## HUEBNER ROAD BUSINESS PARK PRELIMINARY OVERALL AREA DEVELOPMENT PLAN (POADP)

INFORMATION SHEET FOR  
PRELIMINARY OVERALL AREA DEVELOPMENT PLAN  
(P.O.A.D.P.)

Re: Huebner Road Business Park POADP  
#278

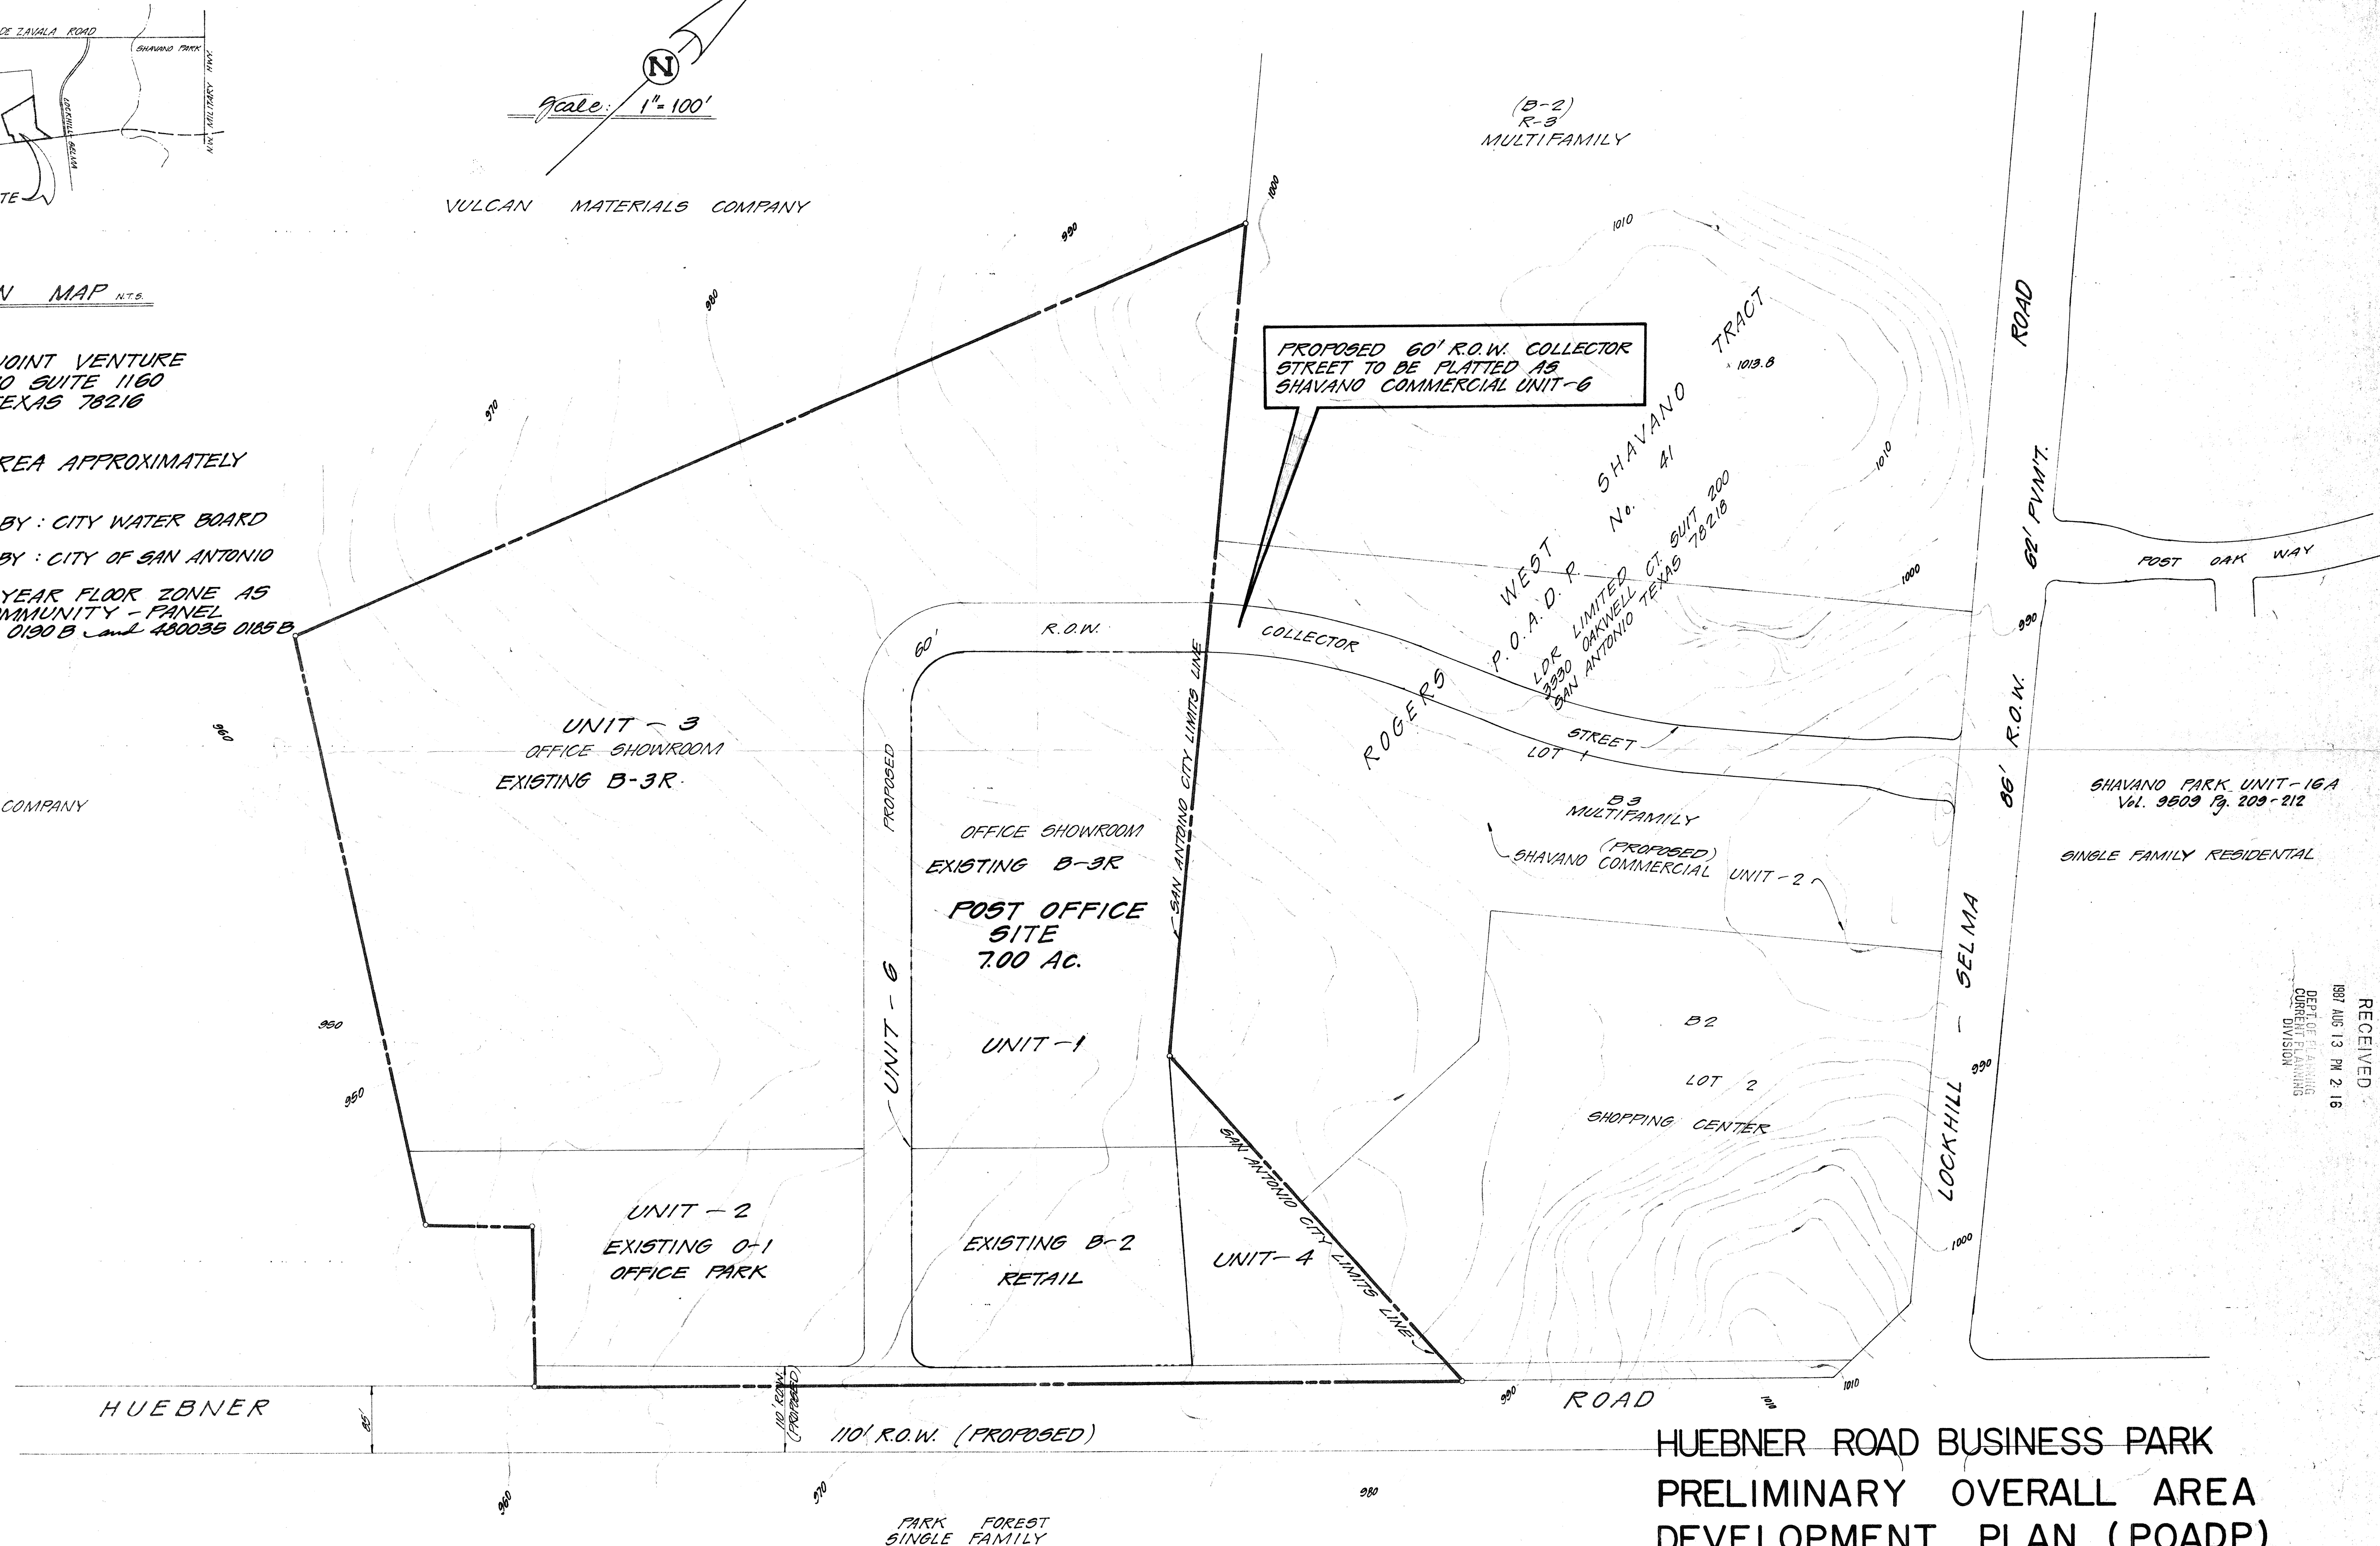
The Development Review Committee has reviewed and accepted your revised plan for Huebner Road Business Park. The plan has been assigned File #278 for future reference. Staff notes that a violation to the 400' centerline radius will be cited upon formal plat filing of the collector street.

- ① Heebner Rd. BUS. Park was submitted Aug. 11, 1987.  
However, the plan does not meet the POADP requirements.  
Mr. Chapa of French Eng. Co. will revise the plan  
and resubmit. (See copy dated 8/11/87 for revisions)
- ② The plan was revised and submitted Aug. 12/1987.
- ③ Committee requested that we meet or talk  
to Wendal Davis re: the adjacent  
Rogers tract. Preference is to align  
the proposed collector with ~~front~~  
Post Oak way Dr. Staff also feels  
uncomfortable with granting a variance  
to the 400'  $\varnothing$  radius.
- ④ The committee reconvened and approved  
the plan on 8/20/87
